**PLANNING DEPARTMENT  
CURRENT PLANNING DIVISION  
MAJOR SITE PLAN REVIEW**

**DATE:** April 15, 2024  
**CASE NO:** 2023-0128  
**APPLICANT:** Shane Thom, Owner  
**REPRESENTATIVE:** Ron Thompson, Scope Permitting and Engineering  
**REQUEST:** Major Site Plan Review for a Multifamily Development per the Special Limitations of AO 85-198  
**LOCATION:** Generally located north of Farm Avenue, east of End Street, south of Davis Street and west of Center Street  
**LEGAL DESCRIPTION:** Lot 5, Block 3, W. G. Pippel Subdivision (Plat P-164A)  
**SITE ADDRESS:** 16543 Farm Avenue  
**COMMUNITY COUNCILS:** Eagle River  
**TAX PARCEL NO.:** 050-101-18-000  
**GRID:** NW0251

② Site Plan  
1" = 50'-0"

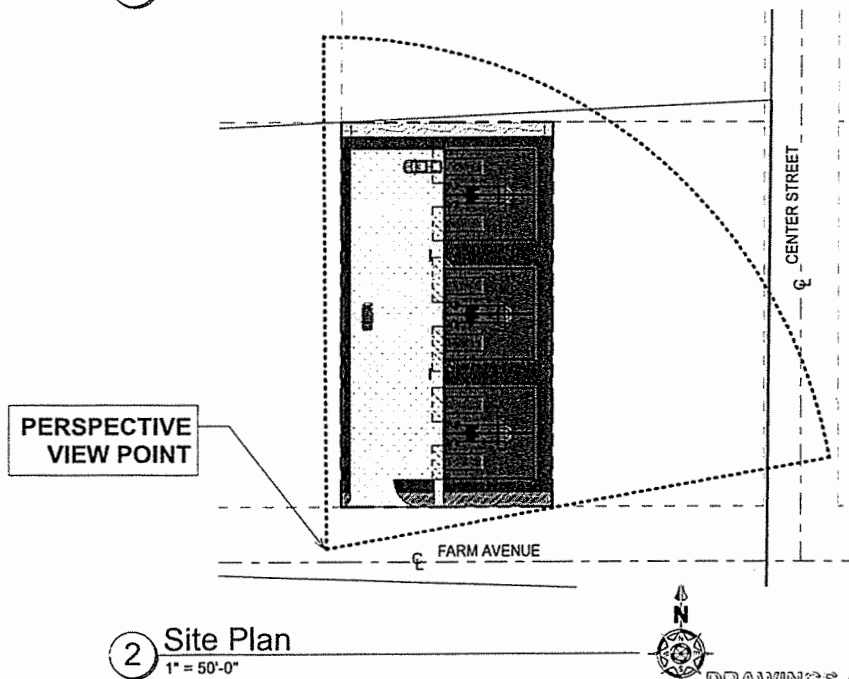
A snow storage area was not shown on the proposed site plan.

The plans provided did not distinguish a vertical separation or change in surfacing material. Provide an updated plan or site plan showing this vertical separation or change in surfacing material.

- a. A snow storage plan or alternative snow management strategy.
  - b. A landscape plan in accordance with AMC 21.07-080C that addresses the following:

- d. Provide vertical separation or change in surfacing material at porches distinguishing between adjoining areas and vehicle parking.
  - e. Provide one (1) amenity from AMC 21.07.060G other than the required 21.07.060G.16.

1  
L102  
Planting Plan  
SCALE: 1" = 20' @ 22x34

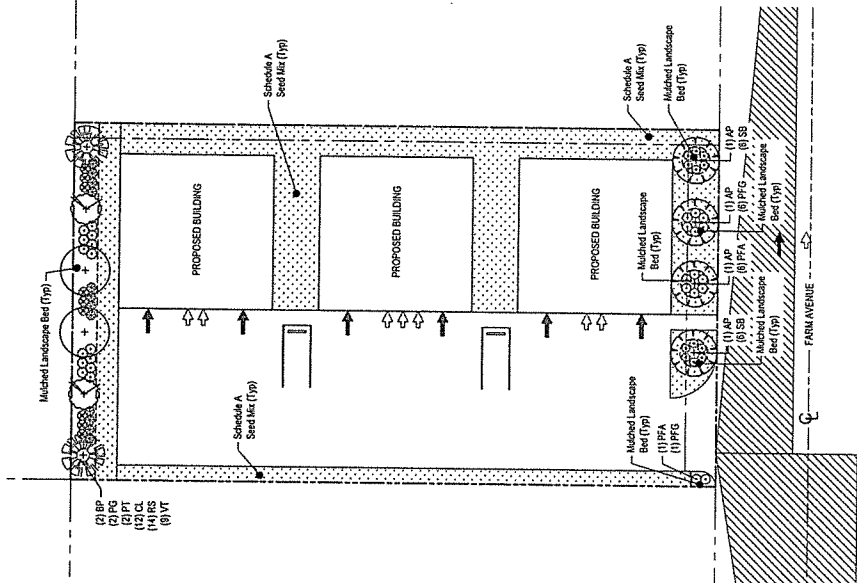
The proposed site plan shows site perimeter landscaping along the northern property line with six (6) trees and along the southern property line with four (4) trees. Ten (10) trees does not meet the minimum eleven (11) trees required for a lot this size.
